TXI Haul Road Variances

City of Austin Environmental
Review Staff: Brad Jackson

Variance Requests

TXI PROJECTS PROPOSED CROSSING LOCATIONS

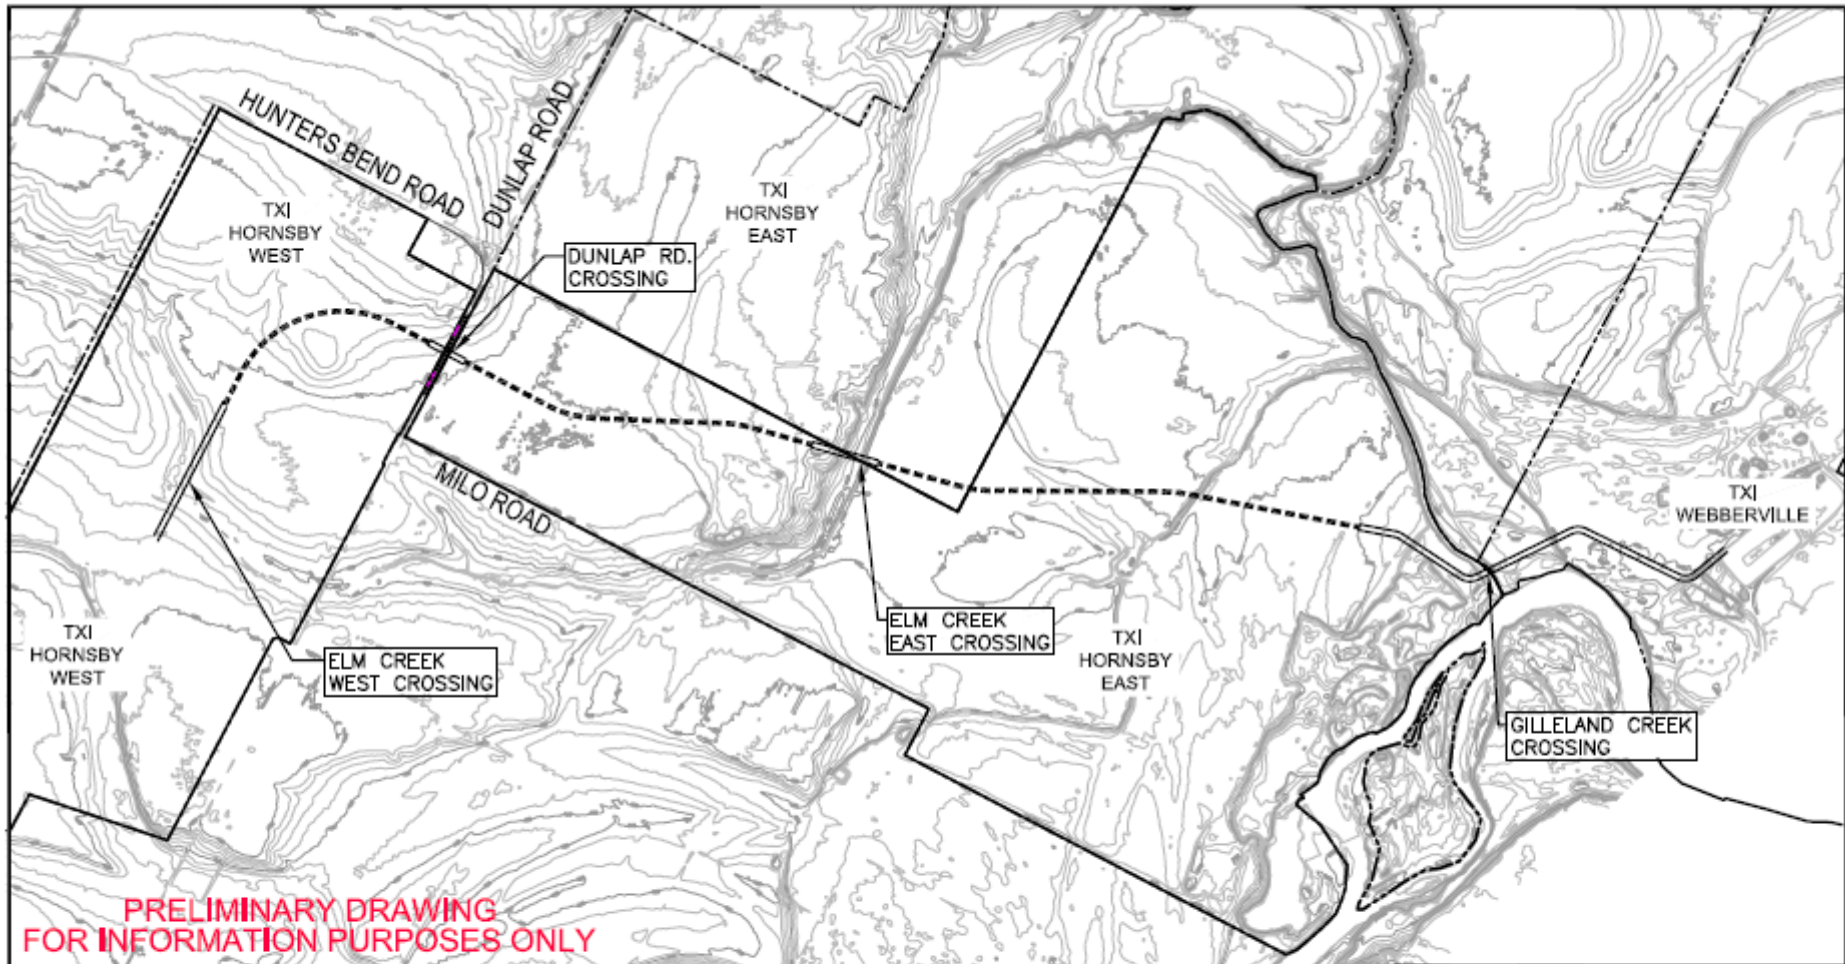
- 25-8-341 (*Cut Requirements*) to allow cut up to 10 feet for construction of the haul road.
- 25-8-342 (*Fill Requirements*) to allow fill up to 10 feet for construction of the haul road.
- 25-8-392 (*Critical Water Quality Zone*) to allow haul road and/or conveyor to cross Gilleland and Elm Creeks at the 3 locations shown in Exhibit A.
- 25-8-281 (*Critical Environmental Features*) to allow a reduced setback for wetlands and wetland mitigation as established in this ordinance.

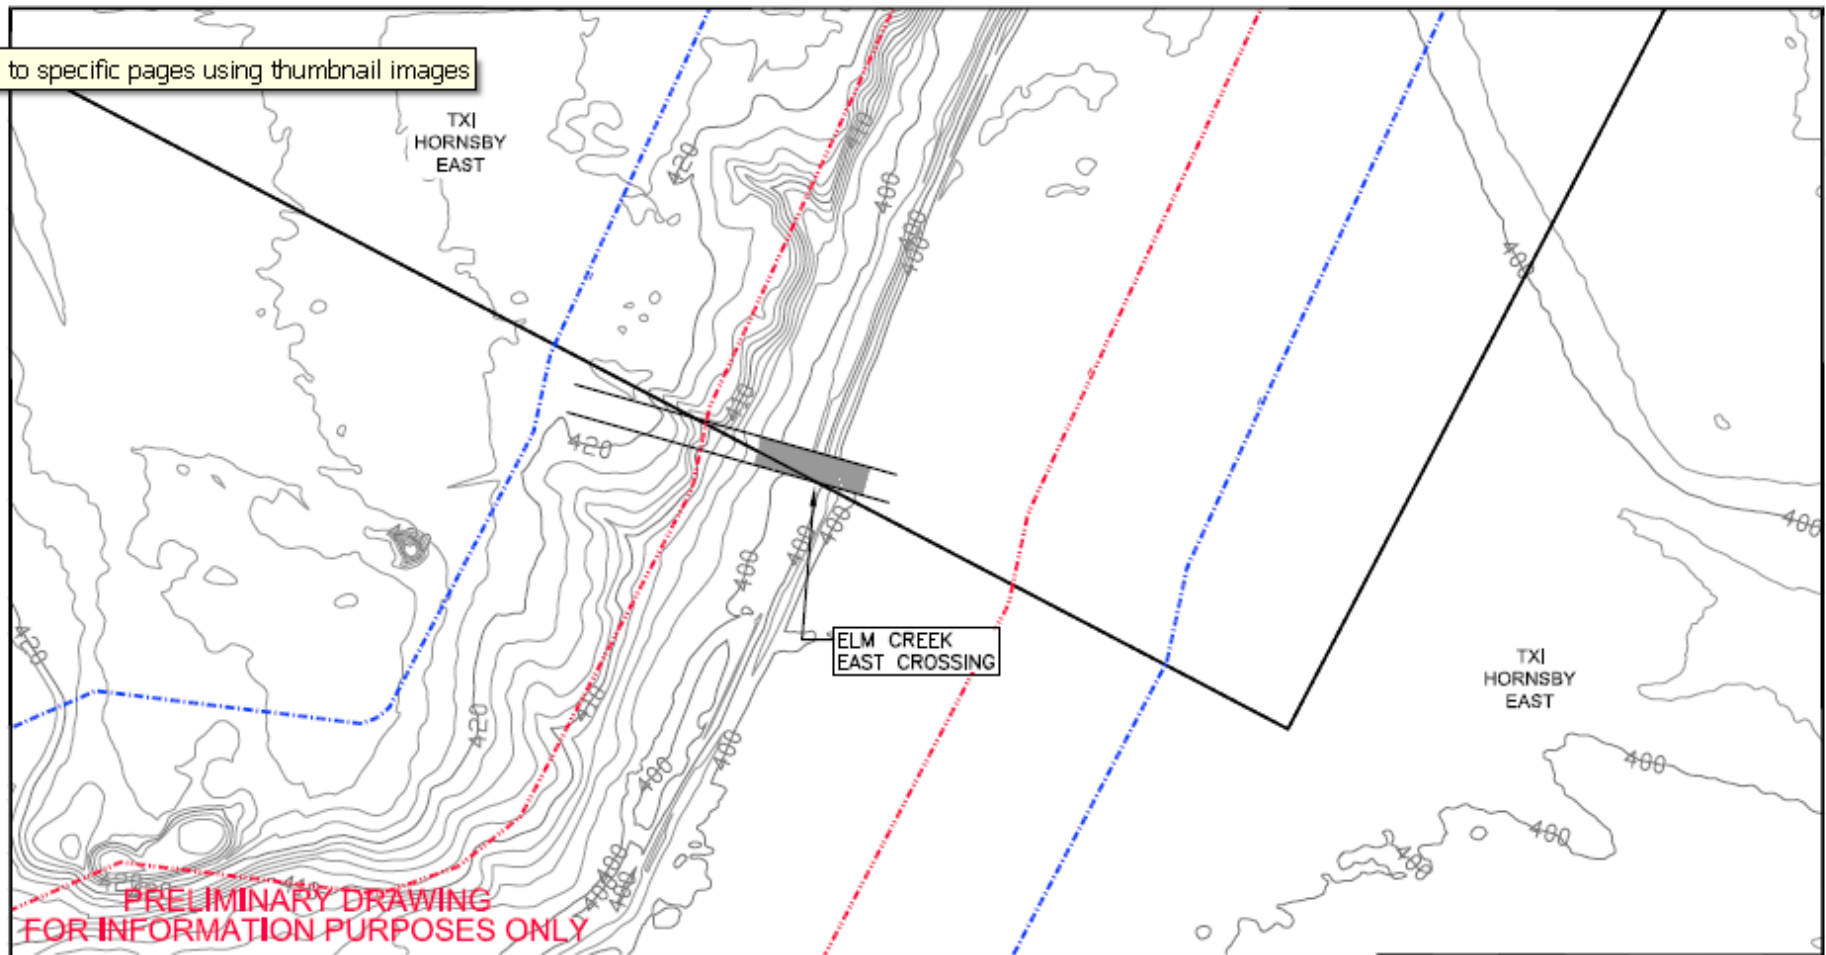
- ◆ Plans filed by TXI shall demonstrate:
 - Armoring and anchoring of crossing for stability and to prevent scour of channel at base flow and up to 100-year storm.
 - Demonstrate TSS removal per ECM section 1.4.4.B.1, section 1.4.4.B.2, and section 1.4.5.K.

Wetland Mitigation Area (Exhibit C)

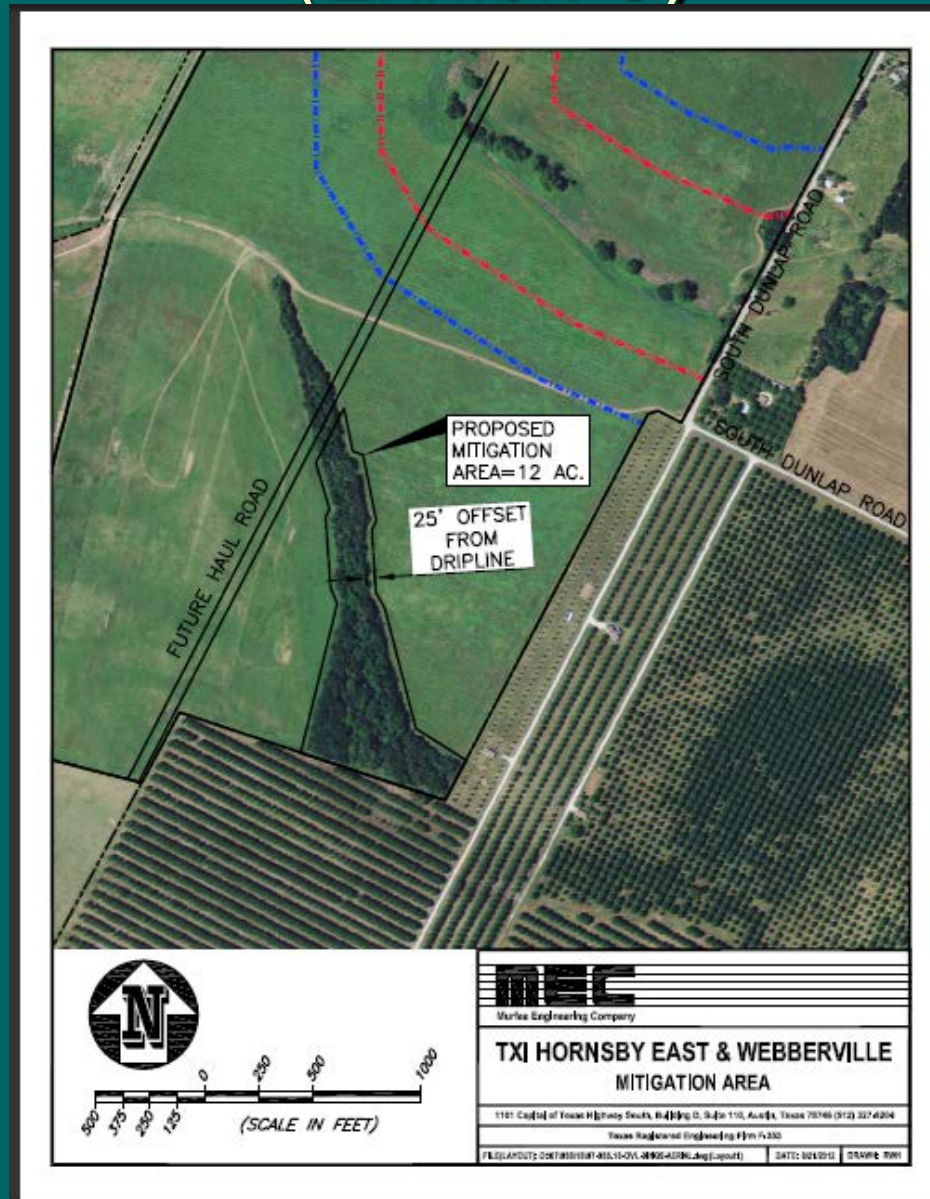
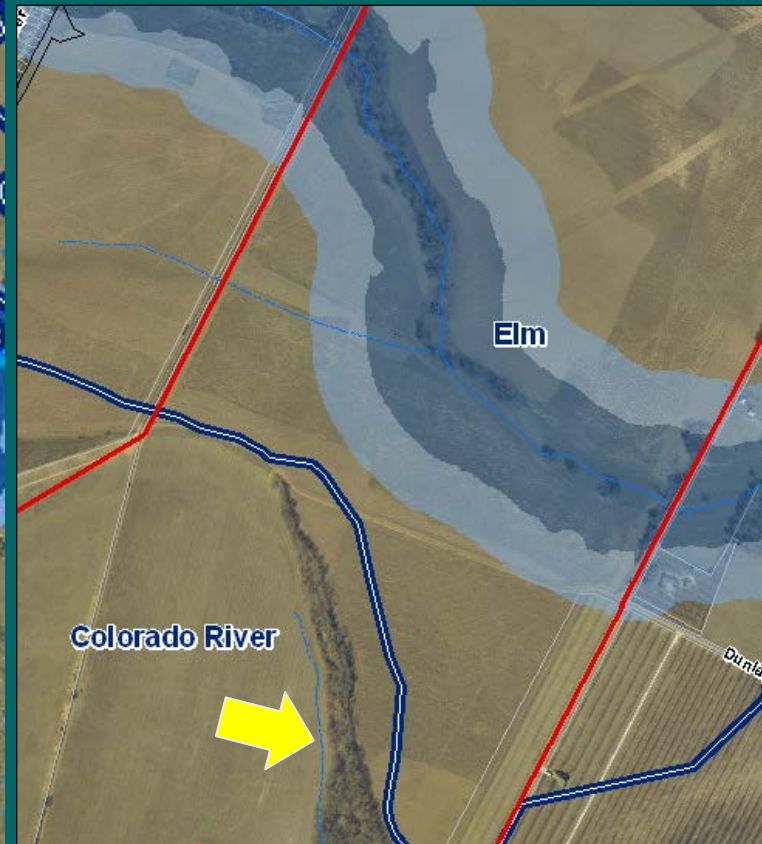
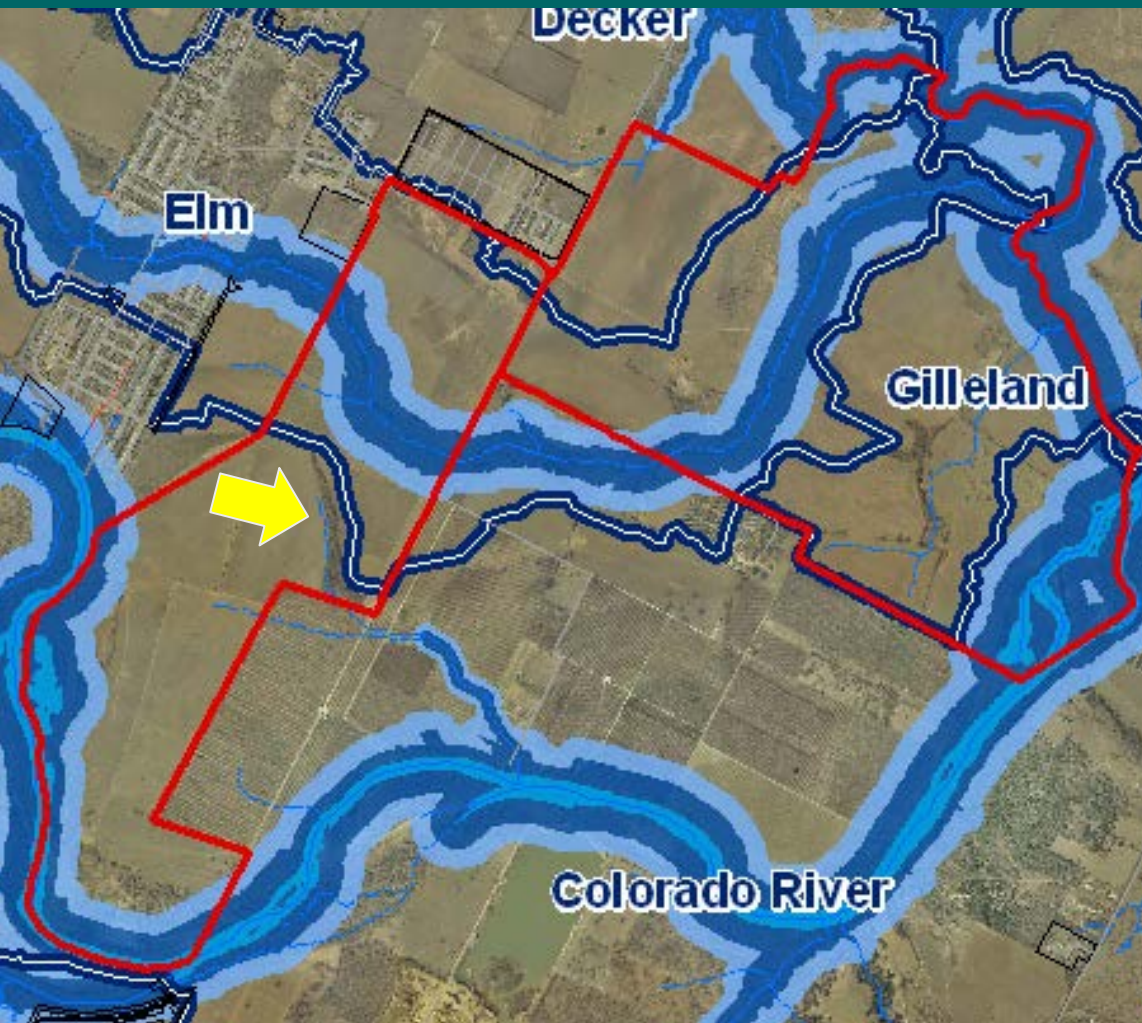
- ◆ Plans filed by TXI shall demonstrate:
 - The limits of construction shall exclude Critical Environmental Feature (CEF) setbacks to the maximum extent feasible.
 - A Restrictive Covenant shall restrict from development and ensure that the wetland mitigation area remains undisturbed and in its natural state in perpetuity.
